23 Prince Albert Road

Design Update Ref: 2023/1709/PRE

Statement of Intent

Proposed balcony alterations- Levels 06 -07
(Balustrade material updated)

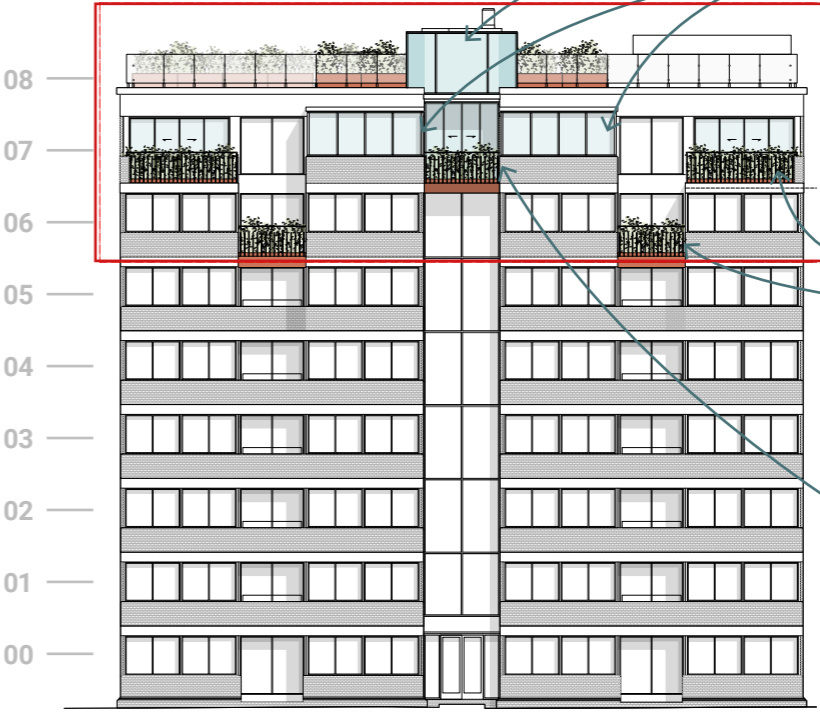
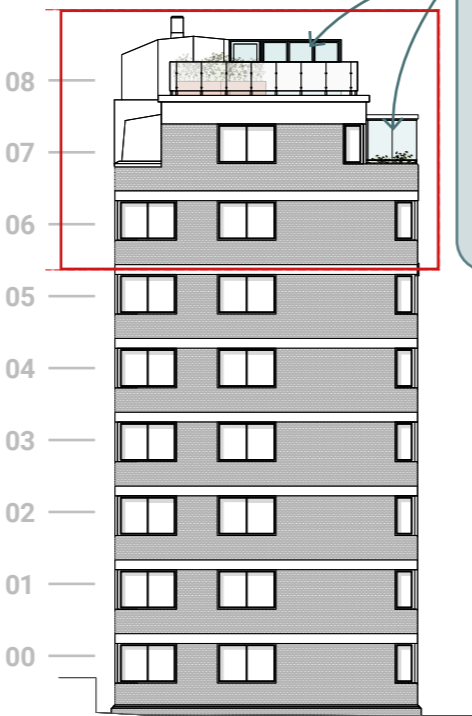
New solid corten railings - Levels 06 - 07

- Existing solid brick balustrades will be replaced by solid, corten steel panels to be in keeping with the character of the existing facade.

Existing brick balustrades replaced by solid, corten steel panels.

Current proposed 3D view from Prince Albert Road

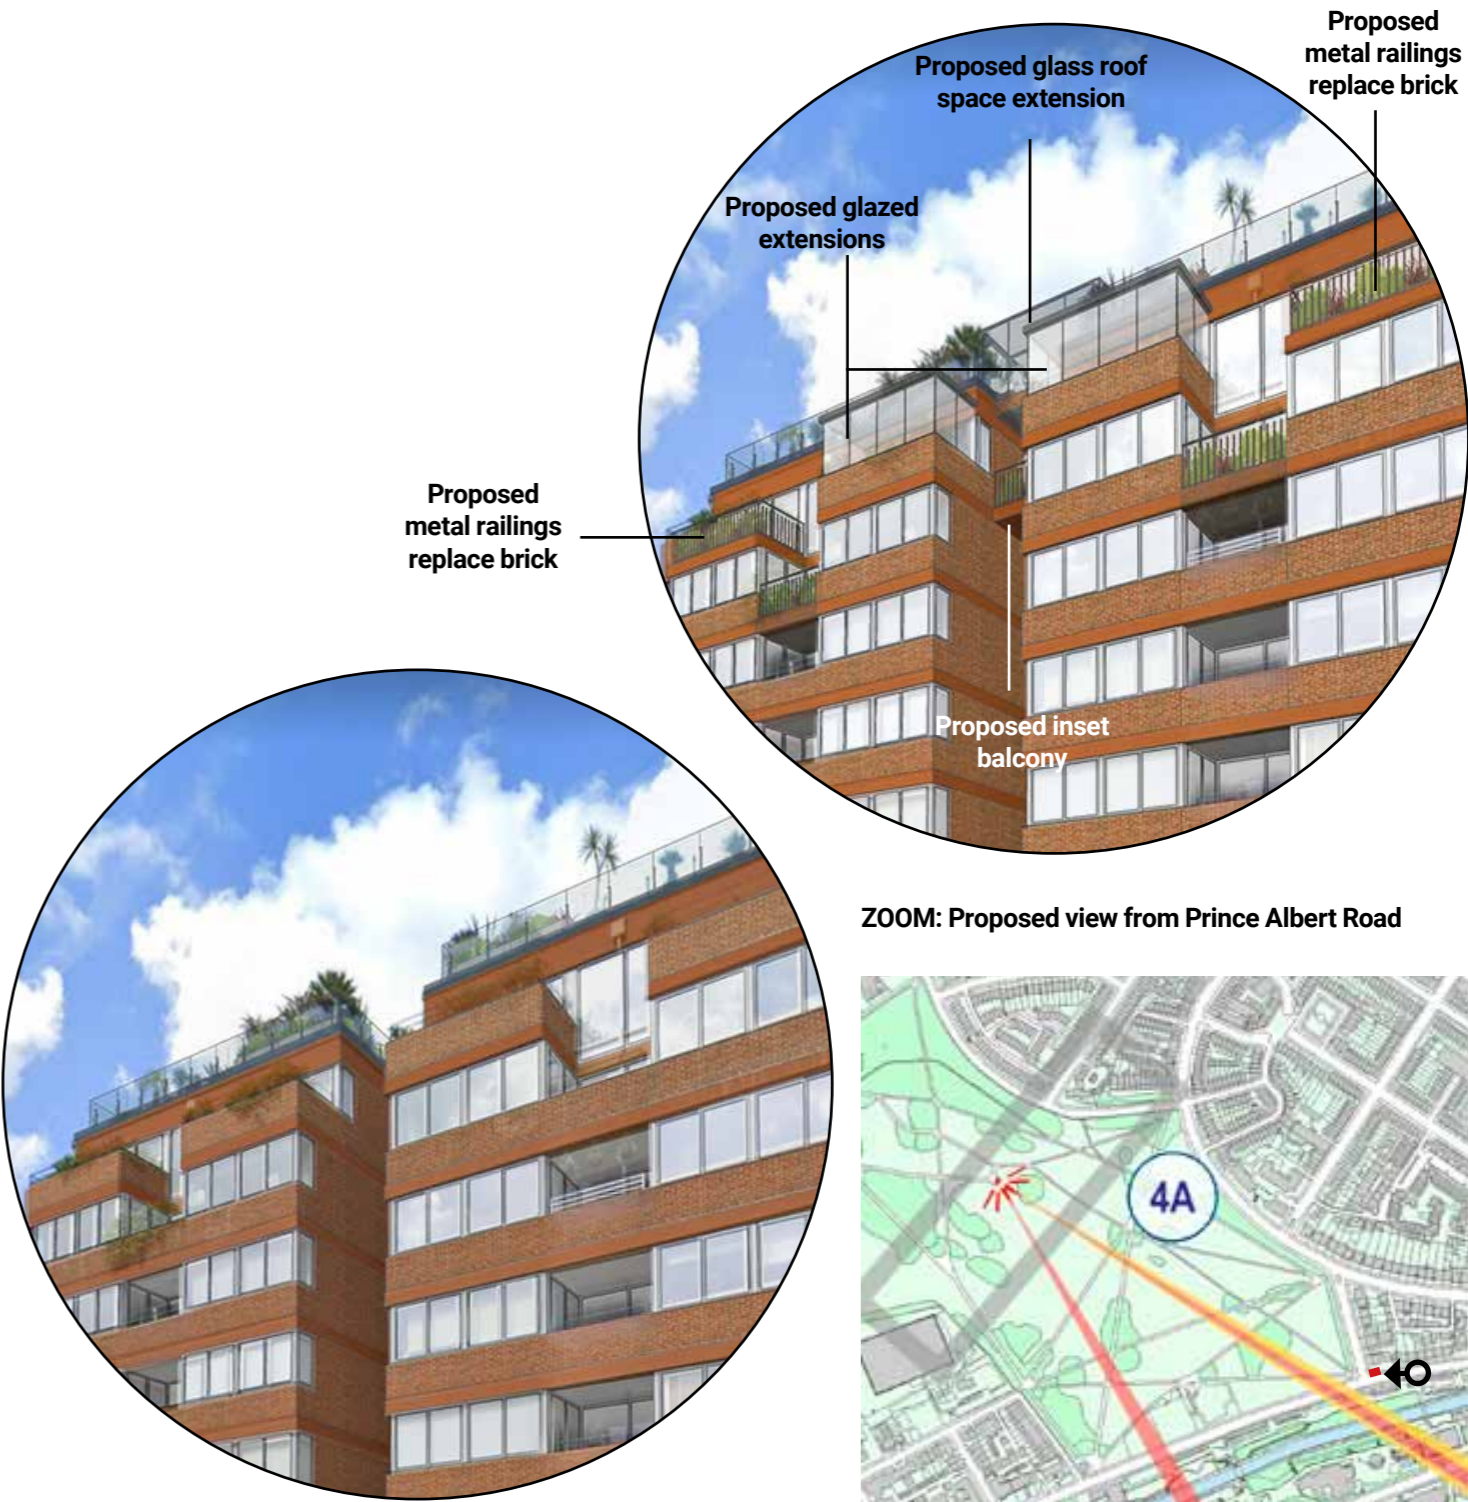
Proposed corten steel panels replace brick

Proposed corten steel panels replace brick
